**RE: Traffic Impact Study Addendum
Berry Hills Phase Eight**

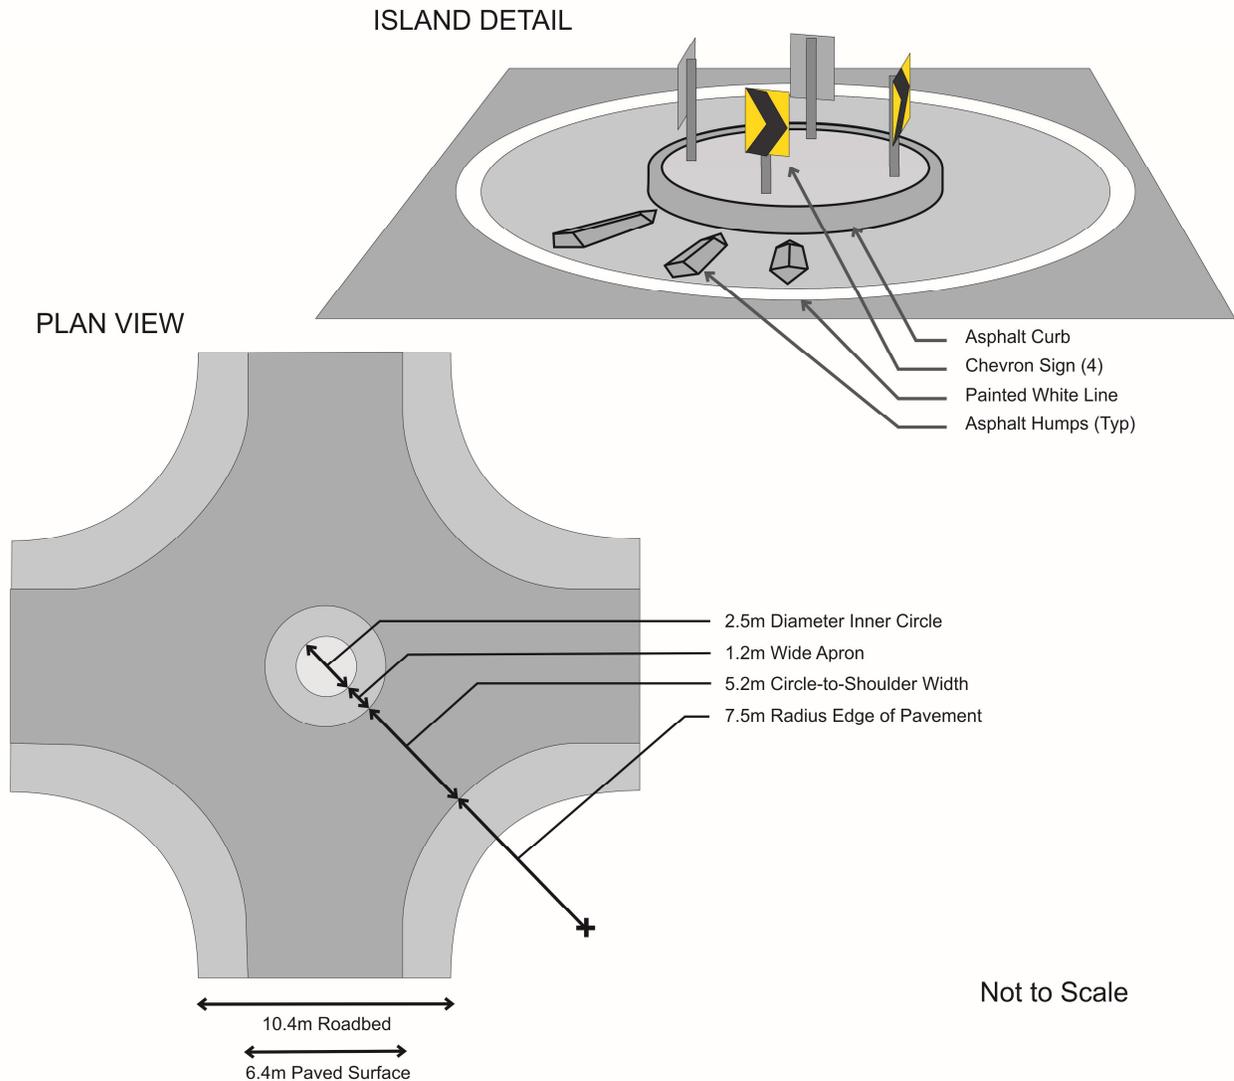
This daily volume warrants the consideration of traffic calming measures on Lively Road. Speed humps are already present on Lively Road and additional measures may not be required. HRM staff have suggested that a mini-traffic-circle at the intersection of the development site access road and Lively Road may help to supplement the traffic calming effect provided by the existing speed humps. At the request of the

Municipality, and recognizing that it has no standard for such a device, a conceptual sketch of a mini-traffic-circle at a local-local intersection has been provided below. The interior circle is only 2.5 meters in diameter, but an apron with radiating raised humps (or “ribs”) is added to increase the effective diameter of the circle without physically hampering the movement of larger trucks. The curb-to-shoulder width of 5.2 meters that results is well above the minimum of fifteen feet suggested by NACTO guidelines for facilities of this type.

We have found, however, that this type of intersection control can not be effectively implemented at a T-intersection, as is the case at the development site connection to Lively Road. The design relies on through traffic migrating onto the cross-street approach and this is not possible when one of the intersection legs is missing. As there are no four-leg intersections on Lively Road, this is not a good device for traffic calming.
